## Referee #1

Authors present the new gap-filling and partitioning method of eddy covariance flux over a complex terrain. The methods were combined several previously proposed methods, and were applied to eddy covariance data at Korean forests. I appreciate the work, because FLUXNET community should solve the known problems that authors did. However, in terms of the scope of Biogeosciences journal, the topic is too specific for the eddy covariance technique. I recommend that further modification in terms of the generalization and clarification of the method, especially for the validation and parameterization. Thus, I decide the manuscript as published after the major revision.

The paper proposes mainly a method to fill gaps and partition the water fluxes in evaporation and transpiration in particular in case of wet canopies. In addition it presents a modification in a data filtering method (ustar) that is used for CO<sub>2</sub>. New methods to partition water fluxes are for sure very interesting and important. For this reason the title is misleading since gapfilling and partitioning of CO<sub>2</sub> are not discussed (or only marginally, without real new developments). Improvem

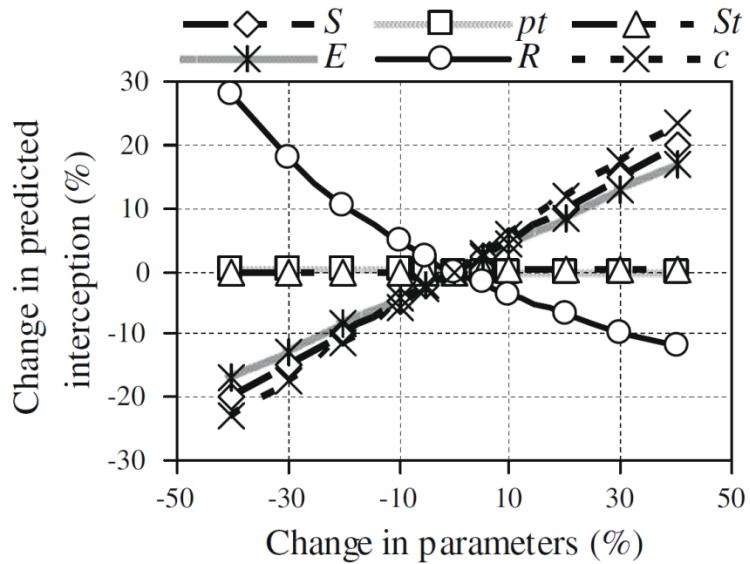
Canopy interception model should be validated based on the hydrological measurements or a test data that is from observed data. Without the validation of the model, readers cannot verify the applicability of the model. Incorrect results, due to inappropriate model and/or parameterization, could bias the gap-filled evapotranspiration. Authors need to discuss further model validation. In addition to the validation issue, I cannot follow how authors determined the appropriate model parameters ( $S$ ,  $k$ ,  $n$ , and  $g_0$ ). If readers want to apply the proposed method, how they will determine the parameters? How is the parameter uncertainties propagate the gap-filled fluxes and partitioned fluxes?

Response: We fully agree with the reviewer's comments. We revised the manuscript as follows.

- (1) Add more detailed explanations how we can obtain the parameters from our field measurement (mainly from the flux tower) and introduce alternative ways (e.g., using MODIS product) **(Page 6 Line 16-27)**
- (2) Add a section for sensitivity analysis of the proposed method similarly to that from Shi et al. (2010), and identify the parameters which significantly affect the gap-filling and partitioning

results. (Appendix C and Fig. C1)

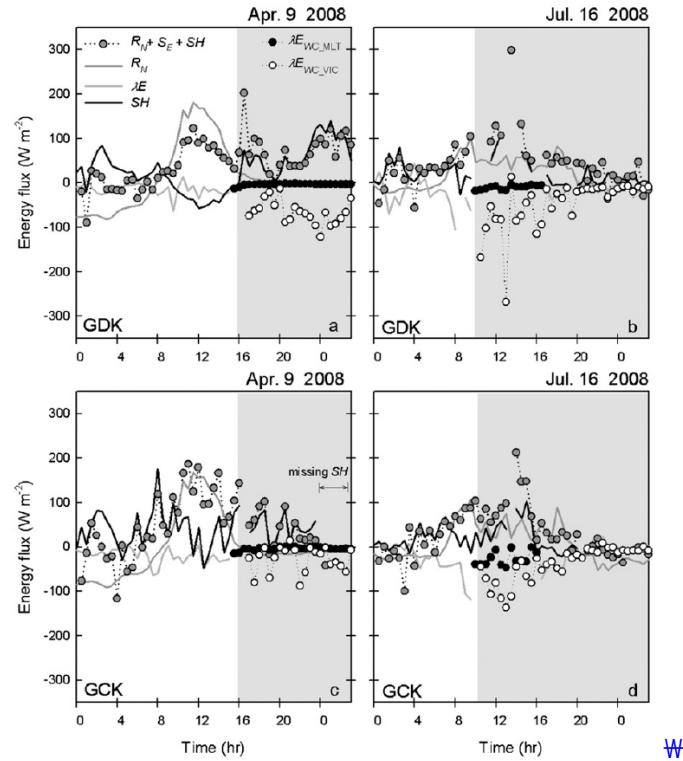
Authors sometime compare the results from the different gap-filling methods or results from previous studies (e.g., Page 11 Lines 24-29). I am not sure which is better, although authors said that the proposed method was better than previous ones without a concrete evidence.

Response: We agree with the reviewer's comment. The underestimation of the gap-filled  $H_2O$  flux under wet canopy condition from the conventional marginal distribution sampling (MDS) method has been shown by the comparison with the sum of energy flux components except latent heat flux (= net radiation + sensible heat flux + storage flux) in our previous study (Kang et al. 2012, the results from the proposed model-stats hybrid method (MSH) displayed the mirrored patterns of the sum of the other energy budget components, while the results from the MDS were  $\sim 0$ , see the below figure).

Based on the previous finding (i.e., Kang et al., 2012) and the validation results (section 3.1.1 in the manuscript), we argued that the proposed method was better.

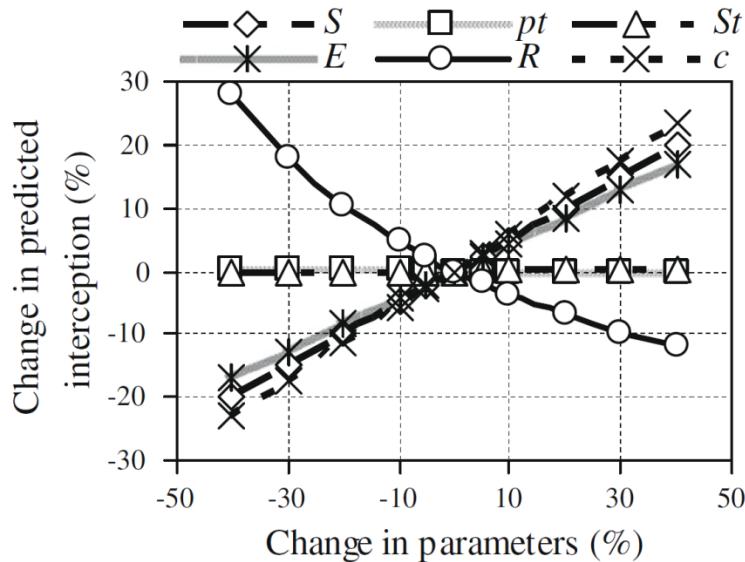
Par 2.3.2: there are a lot of parameters in the proposed model but it is not clear how they are estimated and also which is the associated uncertainty. Also it should be verified if the parameters are valid in different conditions (to test the "everywhere, all of the time" proposed by the authors P3L18). At the moment this is far to be demonstrated.

Response: We fully agree with the reviewer's comments. We revised the manuscript as follows.

(1) Add more detailed explanations how we can obtain the parameters from our field measurement (mainly from the flux tower) and introduce alternative ways (e.g., using MODIS product) (**Page 6 Line 16-27**)

(2) Add a section for sensitivity analysis of the proposed method similarly to that from Shi et al. (2010), and identify the parameters which significantly affect the gap-filling and partitioning results. (**Appendix C and Fig. C1**)

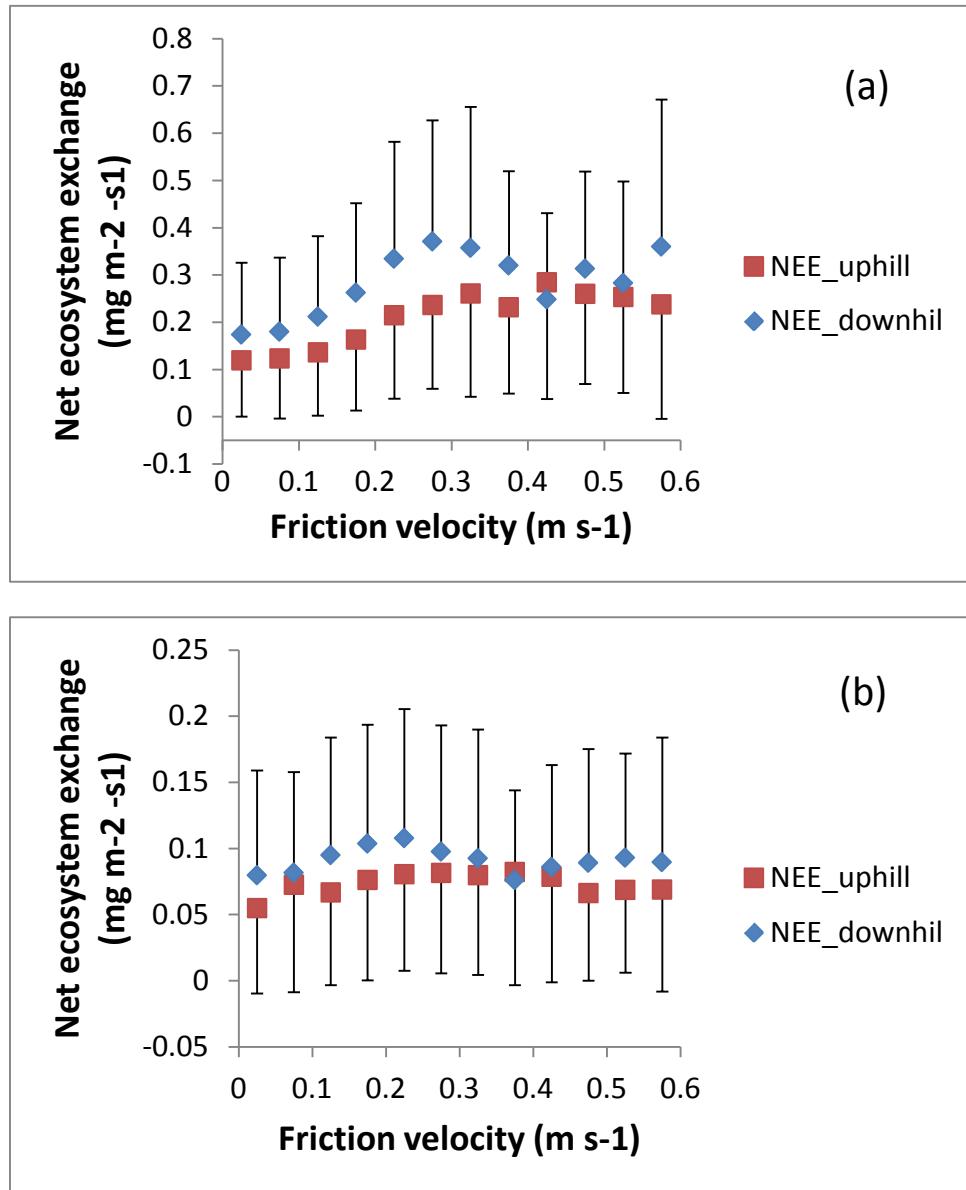
Section 2.4.1 reports the NEE processing but the level of details is not sufficient to understand what is done (how are the parameter estimated? How is the  $u_{\star}$  threshold calculated?). In addition three methods are presented as three independent approached but it is not explained if, when the light response curve method is applied, the data below the  $u_{\star}$  threshold are removed (in this case they are not independent, if not removed that it is an error because it is known that the data are not correct). That said, I also find this part not relevant for the paper that is more focussed on H<sub>2</sub>O.

Response: We mostly agree with the reviewer's comments (except the last argument). We rewrote the section 2.4.1 including the following contents.

We adapted  $0.3 \text{ m s}^{-1}$  of  $u^*$  threshold from Kang et al. (2014 and 2017). We had checked the dependency of nighttime CO<sub>2</sub> flux on friction velocity during the growing and dormant seasons (Fig. 3).  $0.3 \text{ m s}^{-1}$  of  $u^*$  threshold can be determined during the growing season, while it is hard to clearly decide a threshold during the dormant season for the both sites. But, the threshold during the dormant season would be smaller than  $0.3 \text{ m s}^{-1}$ . Therefore, we applied the constant threshold of  $0.3 \text{ m s}^{-1}$  for the sites. (**Page 8 Line 8-12**)

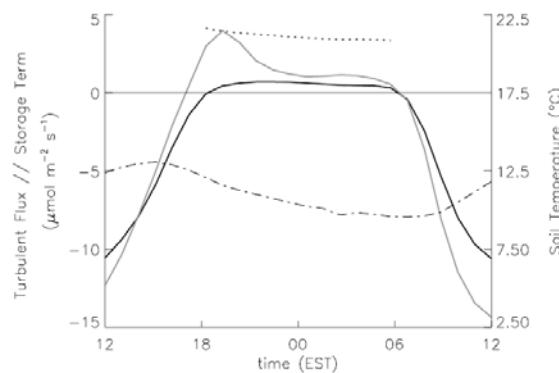
P7L28-30: authors should explain why the MPT method is "inappropriate for hilly terrain sites" while the u<sup>\*</sup> filtering (and so also the MPT) has been developed specifically to filter out the advection.

**Response:** We annexed a proviso: inappropriate for hilly terrain sites "that are usually affected by drainage flow." The advection-based method was developed for such sites (van Gorsel et al., 2007, 2008, and 2009). Figure 4 (copied from van Gorsel et al., 2007) (and Figure 5 which is adapted from Kang et al., 2017, our previous study for the same study sites) shows why it is hard to apply the  $u^*$  filtering method for such sites. During the nighttime except near sunset, the  $\text{CO}_2$  fluxes were close to 0 and much smaller compared with the data from the other independent observation (i.e., chamber), due to drainage flows. It suggests that we should consider not only  $u^*$  but also time (when the drainage flow is fully developed) for nighttime  $\text{CO}_2$  flux filtering. We added such explanation in the introduction and method sections. (**Page 9 Line 7-8**)

Fig. 5. Mean diurnal variations of the observed  $\text{CO}_2$  fluxes and storage terms for the uphill (GDK)

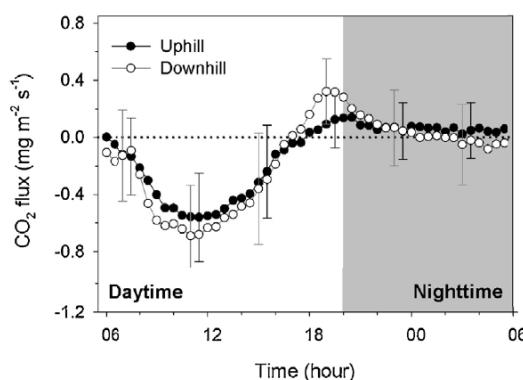
Section 3.2.1: in Figure 5 the comparison of measurements before and after sunset is used to show the presence of drainage. However it is not clear if the data shown in the plot are filtered by *ustar* (they should otherwise the plot is biased by a known issue).

Response: The figure shows the results after applying the  $u^*$  filtering. It also showed that determining the  $u^*$  threshold is difficult when drainage is fully developed due to  $\sim 0$  of  $\text{CO}_2$  fluxes. We modified the caption to avoid such confusion.
